UNITED STATES PATENT AND TRADEMARK OFFICE

APPLICATION NO.	FILING DATE	FIRST NAMED INVENTOR	ATTORNEY DOCKET NO.	CONFIRMATION NO.
09/846,889	05/01/2001	Thomas P. Feist	08CN08803C	5322
23413	7590	08/12/2004	EXAMINER	
CANTOR COLBURN, LLP 55 GRIFFIN ROAD SOUTH BLOOMFIELD, CT 06002			BERNATZ, KEVIN M	
			ART UNIT	PAPER NUMBER
			1773	
DATE MAILED: 08/12/2004

Office Action Summary	Application No.	Applicant(s)	
	09/846,889	FEIST ET AL.	
	Examiner	Art Unit	
	Kevin M Bernatz	1773

DETAILED ACTION

Figure 1: Landin et al. storage medium showing claimed limitations

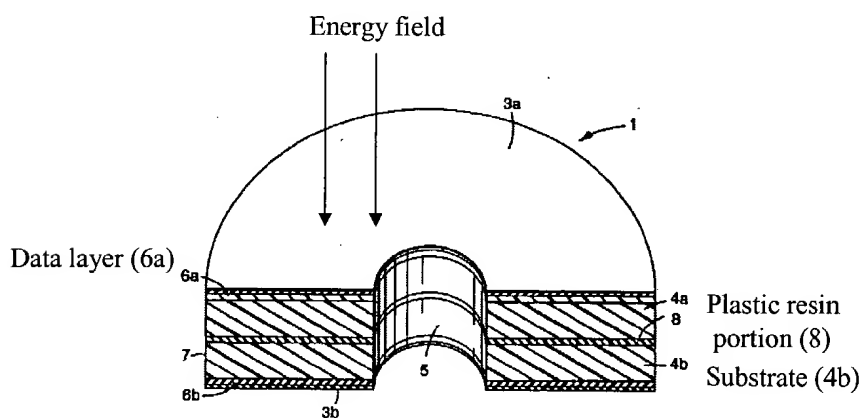
Regarding claims 1, 16, 17 and 24, Landin et al. disclose a method for retrieving data (*col. 2, line 66 bridging col. 3, line 8*), comprising rotating a storage media (*ibid*) comprising at least one plastic resin portion (*see Figure 1 below – element 8*) disposed between at least one data layer (*element 6a*) and a substrate (*element 4b*), directing an energy field (*col. 3, lines 1 – 8 and col. 11, lines 12 - 19*) at said storage media such that said energy field is incident upon the data layer before it can be incident upon the substrate (*since dual layered medium, necessarily happens whether one inverts the image or not¹*), and retrieving information from the data layer via said energy field (*col. 2, line 66 bridging col. 3, line 8*).

Figure 2 – Laminated substrate comprising 2 damping portions

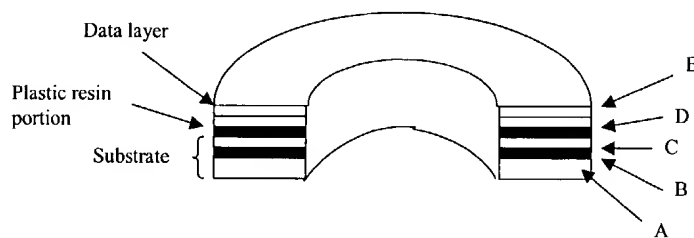
Regarding claim 32, the Examiner notes Figure 2 below, which represents an alternative embodiment disclosed by Landin et al. (*col. 5, lines 1 – 30 and Figures 2- 4*).

In the above Figure, layers A, B and C represent applicants' "substrate", wherein layer B comprises damping material. Layer D is a second layer of damping material and reads on applicants' claimed "plastic resin portion" with layer E being the data storage layer (see *Landin et al. Figures 2 and 3, wherein Landin et al. teach that the substrate can preferably be formed by simply laminating alternating layers of substrate + damping material in col. 5, lines 1 - 30*). The Examiner notes that Landin et al. teach that the damping material can comprise resins meeting applicants' claimed limitations (*col. 6, lines 63 – 67*).

Regarding claims 42 and 45, Landin et al. disclose a "core" having a substantially constant thickness (*see Figure 2 above – element B*).

Regarding claim 47, Landin et al. disclose that the “core” shown in Figure 2 above (*layer B*) can include hollow cavities (*Landin et al. – Figure 4b and col. 10, lines 1 – 10*).

Regarding claims 53 and 55, Landin et al. disclose an insert meeting applicants’ claimed structural limitations (*Figure 2 above, wherein the “substrate” is element C, the plastic resin portion is element D, the data layer is element E, and the insert is element B*).

Figure 3: Illustration of "varied thickness" of substrate portion of Landin et al.

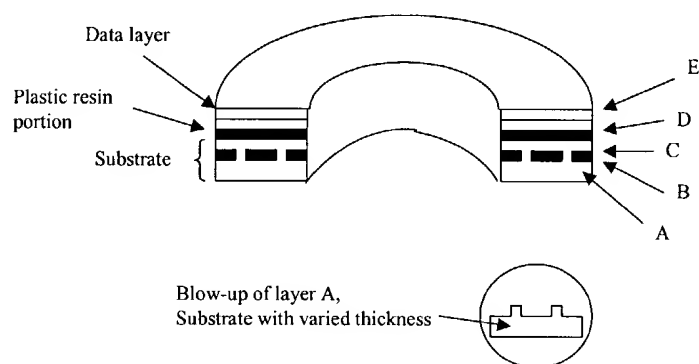
Regarding claim 40, Landin et al. disclose substrates comprising hollow portions (*Figure 4b*), which the Examiner deems would read on the limitation "having varied thickness" in the embodiment represented by Figure 2 above (*see Figure 3 below, element A*).

Regarding claims 43, 46, 48, 49 and 50, Landin et al. disclose a “core” having varied thickness including filled cavities (i.e. multiple portions comprising different materials – claims 49 and 50) (see *Figure 3 above, layer B*) wherein the “core” would result in rings meeting applicants’ claimed Markush limitation in claim 46.

Regarding claim 54, Landin et al. disclose an insert meeting applicants' claimed structural limitations (*Figure 3 above, wherein the "substrate" is element C, the plastic resin portion is element D, the data layer is element E, and the insert comprising a plurality of portions is element B*).
